MONTGOMERY COUNTY HISTORIC PRESERVATION COMMISSION
STAFF REPORT

| Address: | 5815 Cedar Parkway, Chevy Chase | Meeting Date: | 3/11/2026 |
| Proposal: | Building Additions and Window Replacement | | |

Figure 2: 1927 Sanborn map showing a small one-story porch in the location of the rear addition.

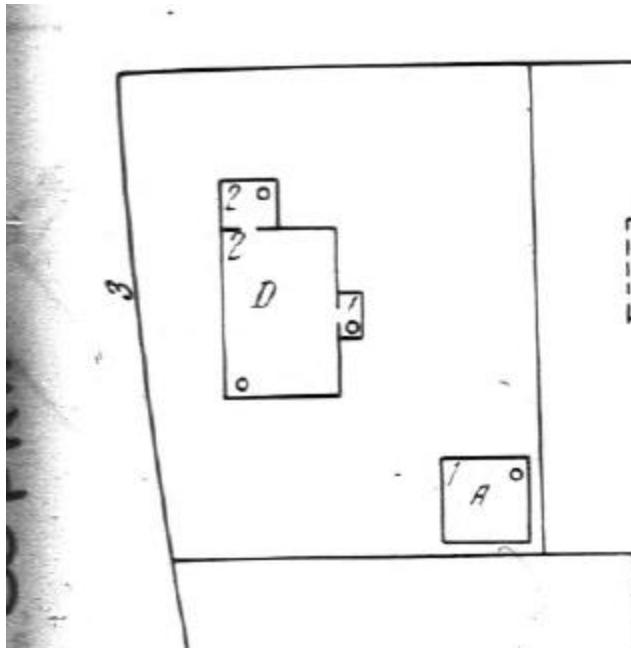
The applicant proposes to construct a two-story rear gable addition off of the historic block of the house and a shed-roofed dormer on the rear of the 2008 addition. Staff finds the additions' overall effect to the surrounding district will be minimal and recommends the HPC approve the HAWP.

1
A-104 **PROPOSED ROOF PLAN**
SCALE: 1/4" = 1'-0"

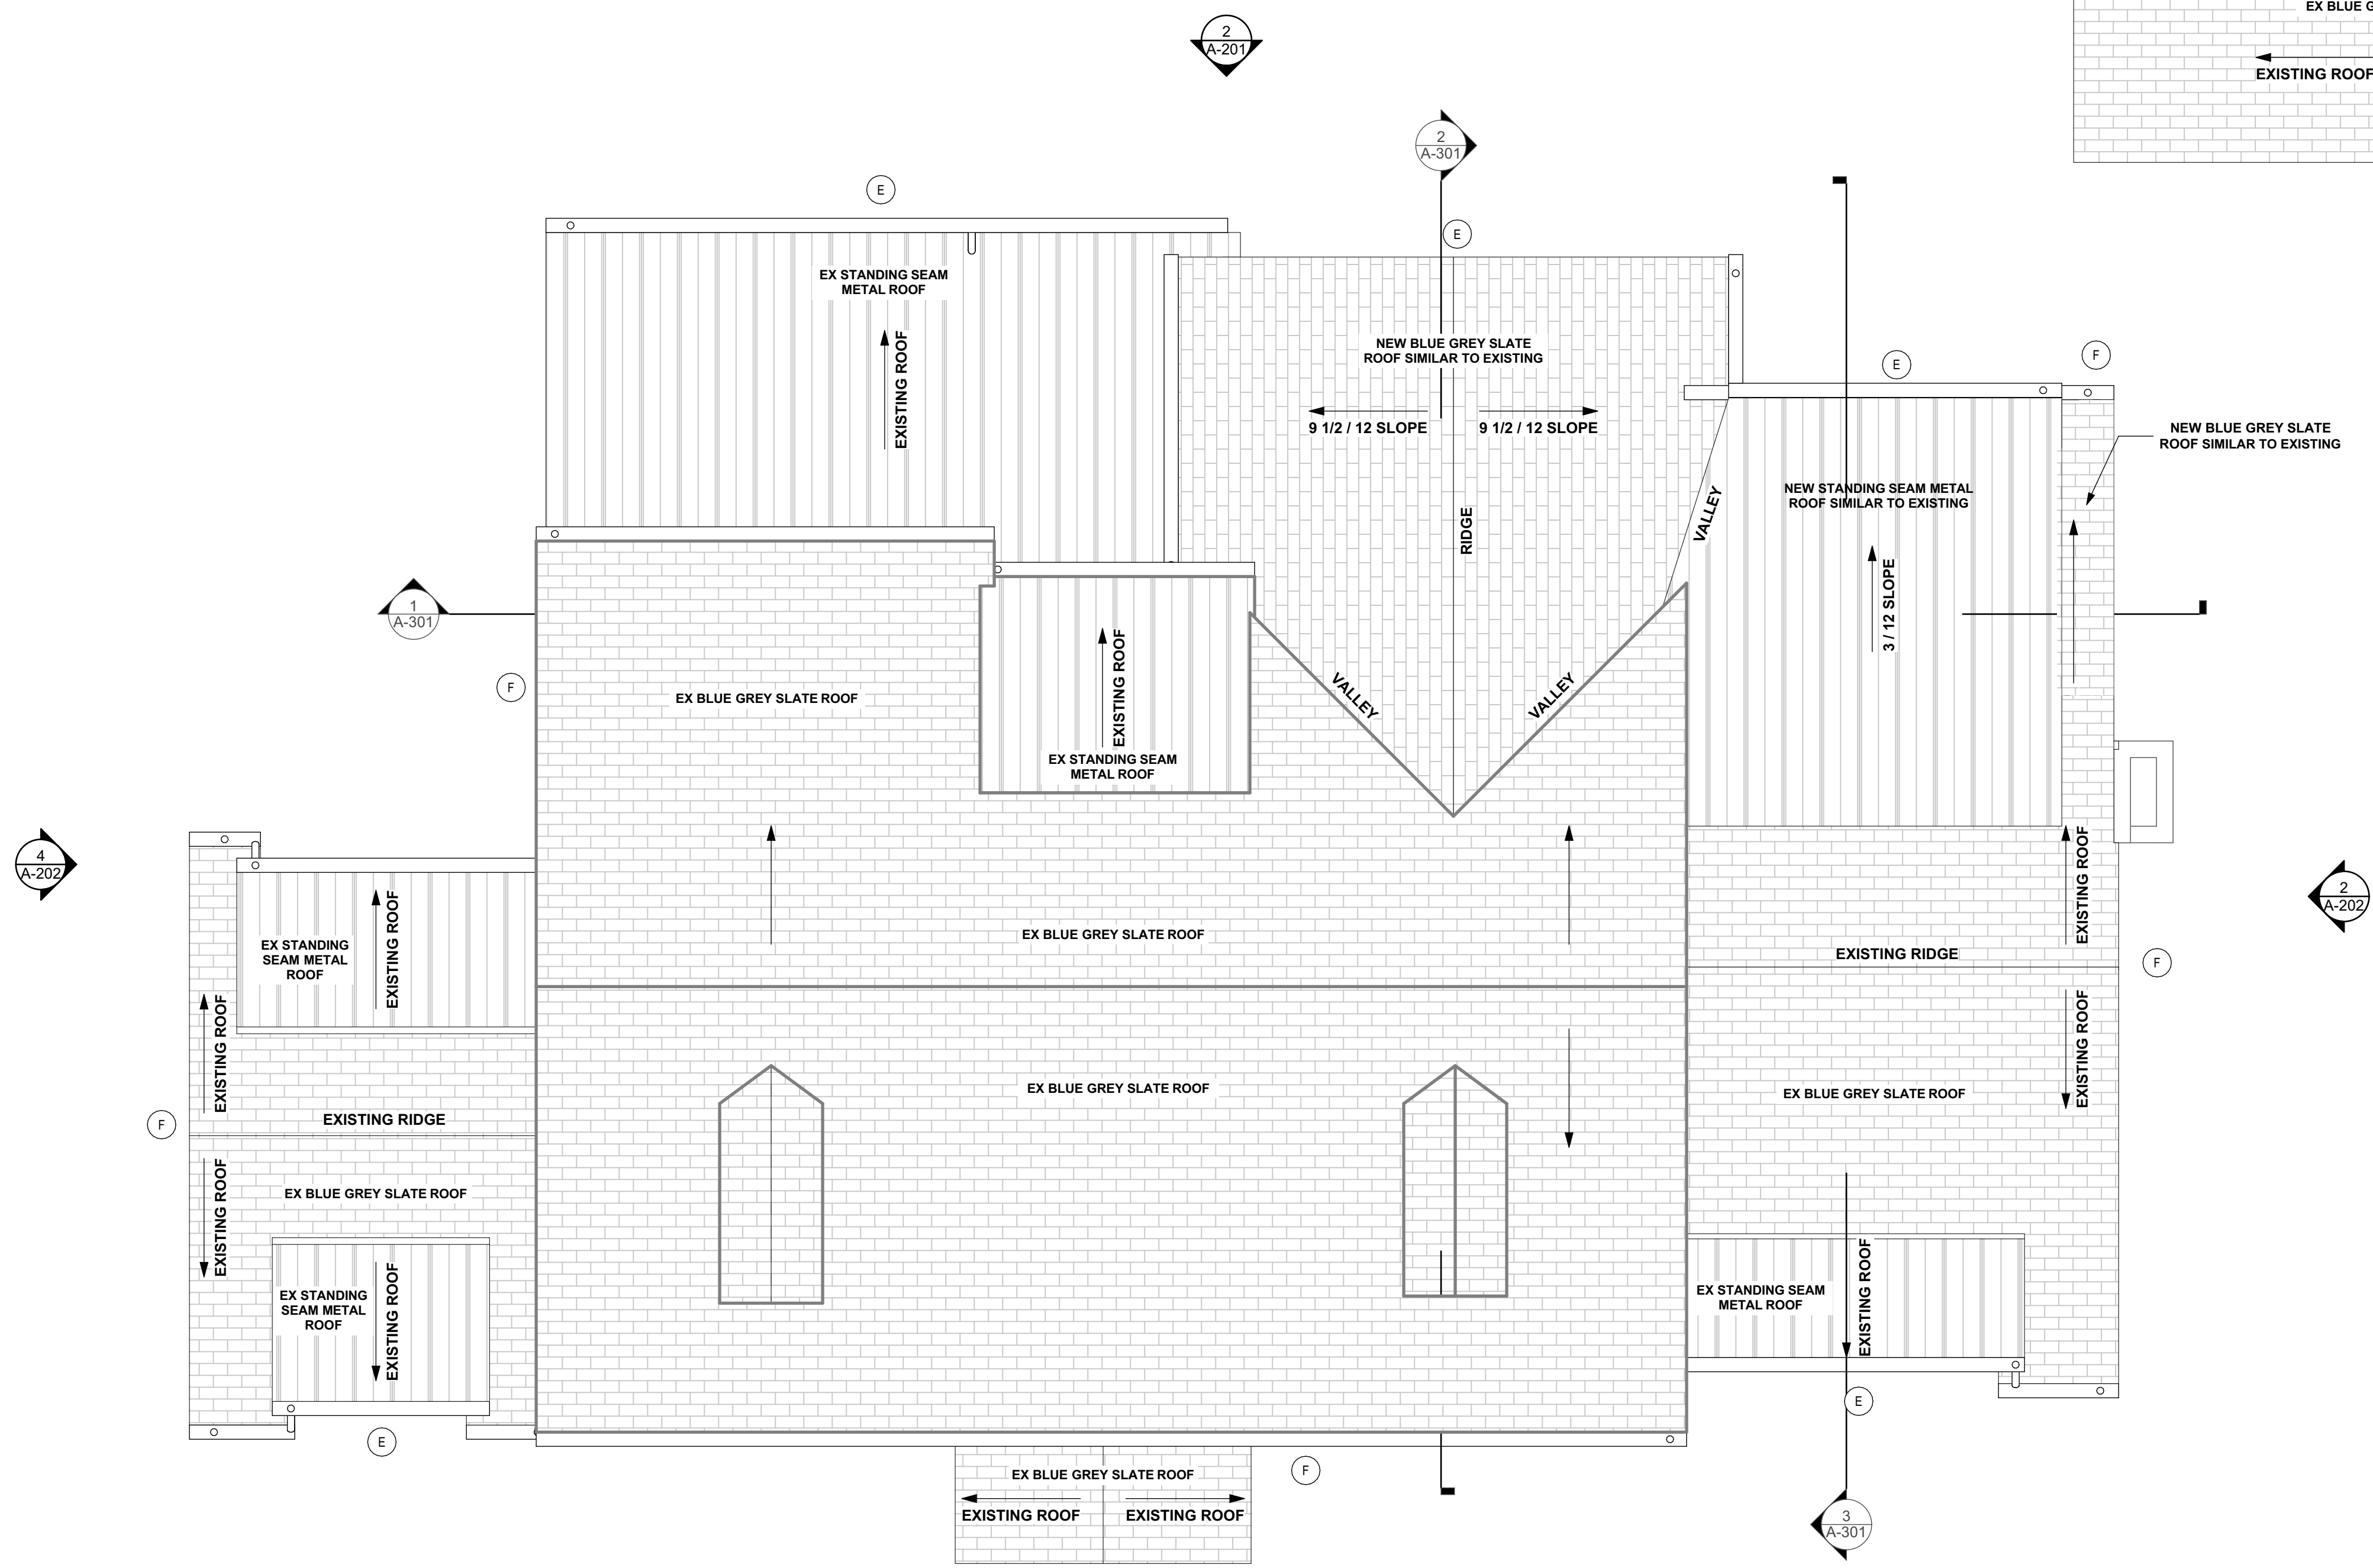
On the rear roof slope of the 2008 right (south) addition, the applicant proposes to install a shed-roofed dormer. The dormer will be 13' 10 3/8" (thirteen feet, ten and three-eighths inches) wide, which will leave a 2' (two feet) of the existing slate roof exposed on the south side. The addition will be sided with wood clapboards to match the existing siding, with a standing seam metal roof. The rear elevation will have three windows, an 8/8 sash window and a six-lite fixed window. The proposed windows are Marvin Elevate windows which are a fiberglass clad wood window with exterior and interior grilles and a spacer bar between the panes of glass.

Staff finds the southwest corner of the proposed dormer will be partially visible from the public right of way. Under a moderate scrutiny level of review, Staff finds the proposed dormer will be installed above non-historic addition, so it will not have a significant impact on historic fabric and is appropriately scaled so it will not overwhelm the character of the historic house and surrounding historic district. Staff finds the design of the proposed is appropriate and recommends approval under 24A-8(b)(2) and (d); *Standards #2 and #9*, and the *Design Guidelines*.

Staff finds the proposed siding and standing seam roofing are compatible with the character of the house. The windows, which will not be at all visible from the public right-of-way are to be reviewed under lenient scrutiny. The *Guideline* for windows includes the recommendation that aluminum and vinyl windows should be discouraged. Staff finds the proposed Marvin Elevate windows are appropriate for two reasons. First, the windows are going into new openings on the rear of the house and will not impact any of the existing windows. The second reason Staff finds the proposed window to be appropriate is that the HPC recently evaluated this specific window for a HAWP in Takoma Park.² In evaluating the proposed window, the commissioners found that the factory finish of the window was not shiny like a vinyl window and was instead consistent with an aluminum-clad window; and would be an appropriate replacement in a situation where the historic windows had previously been removed. Commissioners additionally found the profiles had the appropriate depth. In general, Staff finds the quality of finish on aluminum and some synthetic windows has improved substantially from 1991, when the *Guideline* for windows was adopted, but still encourages the HPC to evaluate window specifications on a case-by-case basis. Staff finds the proposed materials are appropriate under 24A-8(b)(2) and (d); *Standards #2 and #9*, and the *Design Guidelines*.

NEW MARVIN ELEVATE DOUBLE HUNG WINDOW SIMILAR STYLE TO EX

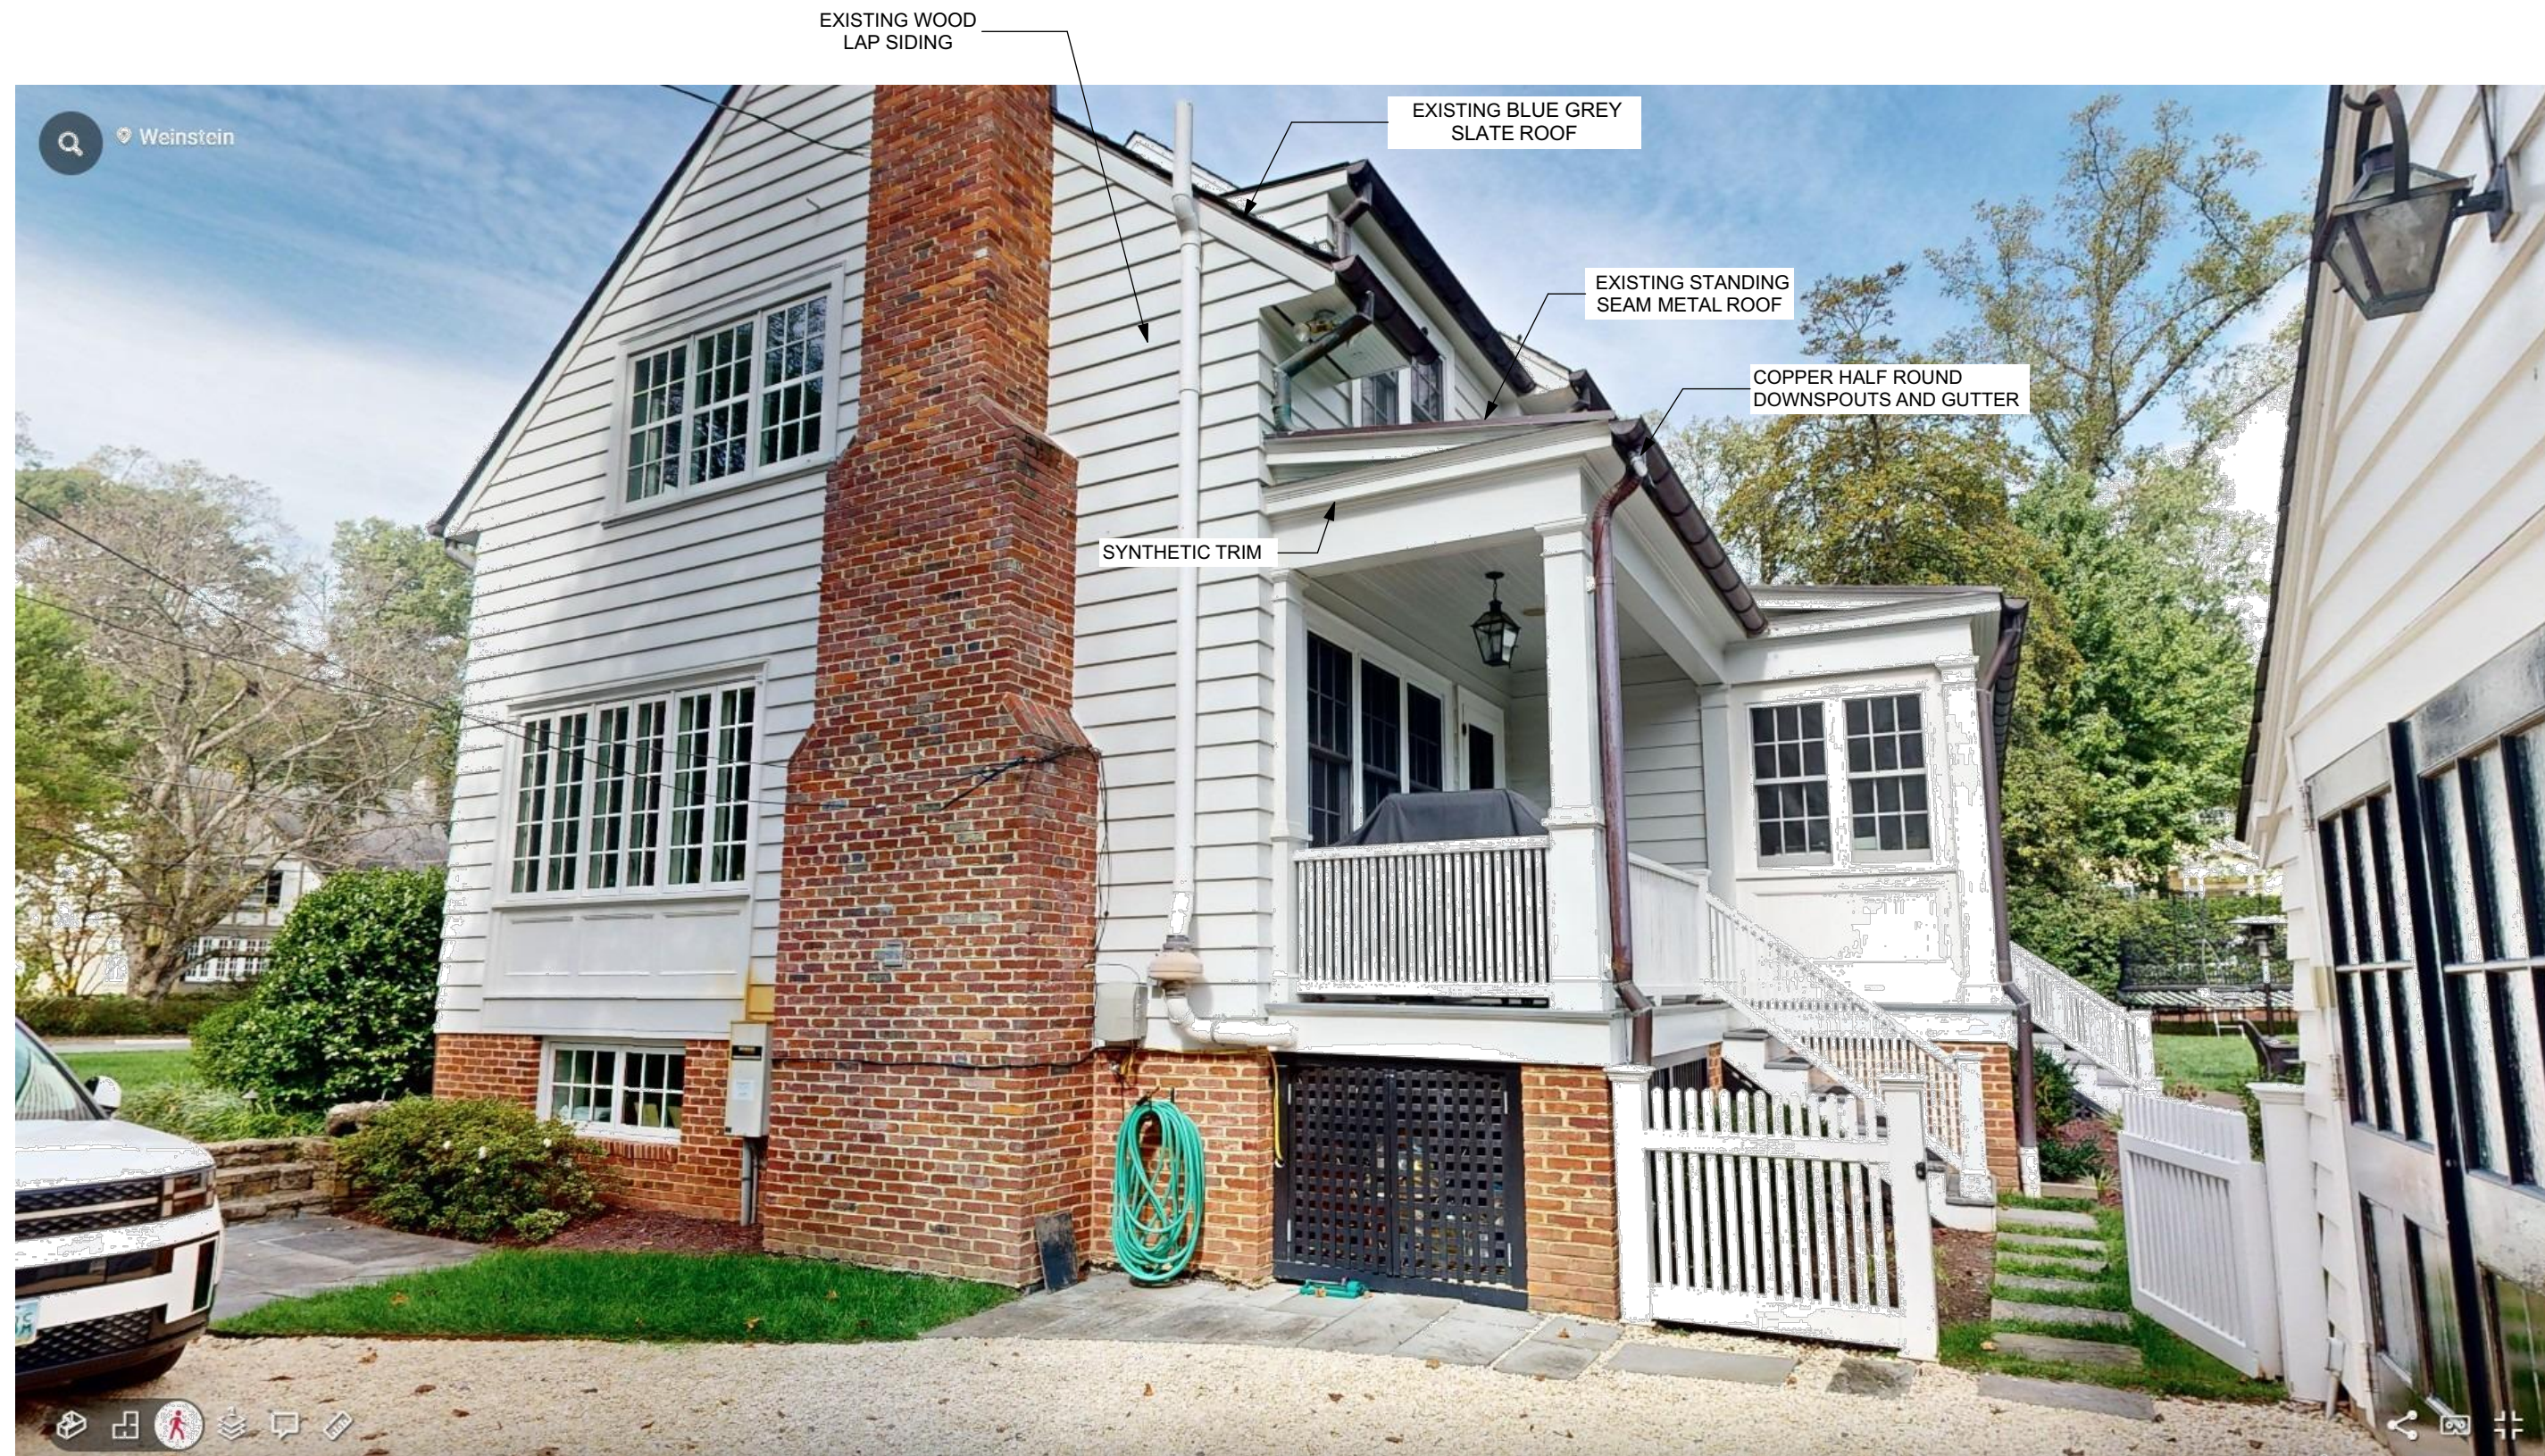
As with the windows on the rear dormer, Staff finds the proposed windows are appropriate as they will be minimally visible from the right-of-way and are not replacing historic fabric.

As with the discussion of Marvin Elevate windows above, Staff finds the proposed replacement window is appropriate on the rear elevation of the subject property and recommends the HPC approve the window replacement under 24A-8(b)(2) and (d); *Standards #2 and #9*, and the *Design Guidelines*.
